STAFF REPORT

PLANNING & ZONING COMMISSION

Village Green Municipal Building, Council Chambers
47 Hall Street
Wednesday, June 13, 2018
7:00 P.M.

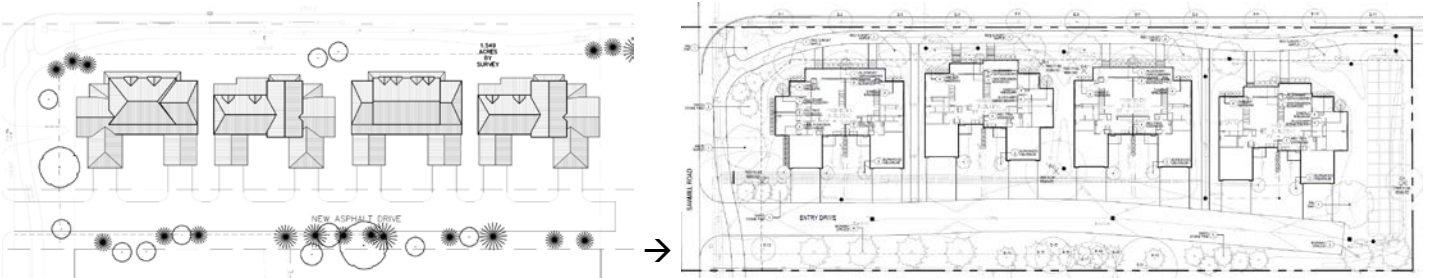
1. Project now named Mews at Zion.
2. A new site plan showing the location of the proposed buildings.
3. New elevations and material selections for each building (see image below – not to scale).

IMAGE 1

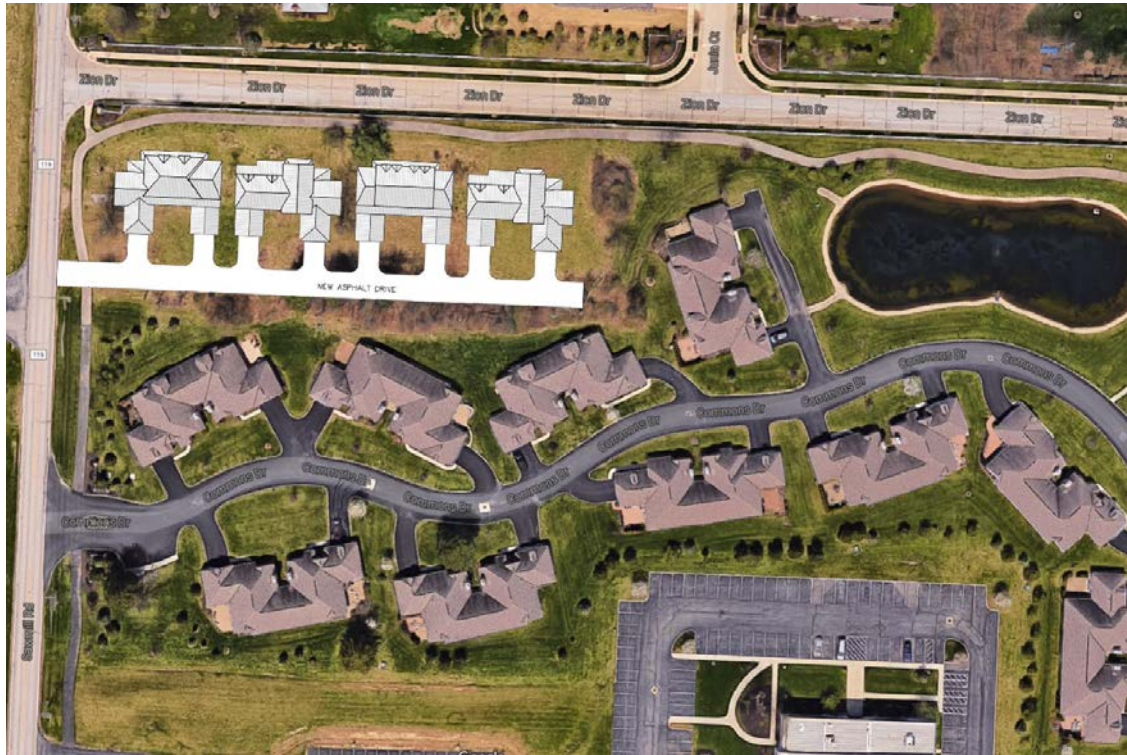
Staff is pleased with the revised site plan, number of units, and elevations presented. Furthermore, staff commends the applicant for following staff's comments and suggestions in order to create a proposal that is much more in line with P&Z's comments.

Other items to consider are the density, scale of buildings, architecture, effect on roadways, and impacts on schools. Overall, the development addresses each of these concerns. One, this new proposal of 5.26 dwelling units per acre (du/ac) is within the densities allowable in the Planned Residence District (PR), which is 9 du/ac. The proposed density of 5.26 du/ac is higher than the 2.98 du/ac of The Commons of Powell to the south. However, a higher density development on a corner parcel is acceptable, and possibly beneficial as a barrier between the road and the less dense existing development. Two, the development is of similar scale to the buildings to the south and as a result, will blend into its surroundings better. Three, the new architecture is of high quality, which helps to be in-line with city's Comprehensive Plan calls for. Furthermore, the fine architecture which is somewhat of a "farm-style" aesthetic would further improve a piece of the city. Lastly, the total 8 units will be geared to empty-nesters and retirees. In turn, they will have little impact of roadways and schools since the users of these type of units have fewer car trips and children than single family homes. As a result, staff does not consider any potential negative traffic impact generated by the proposed development.
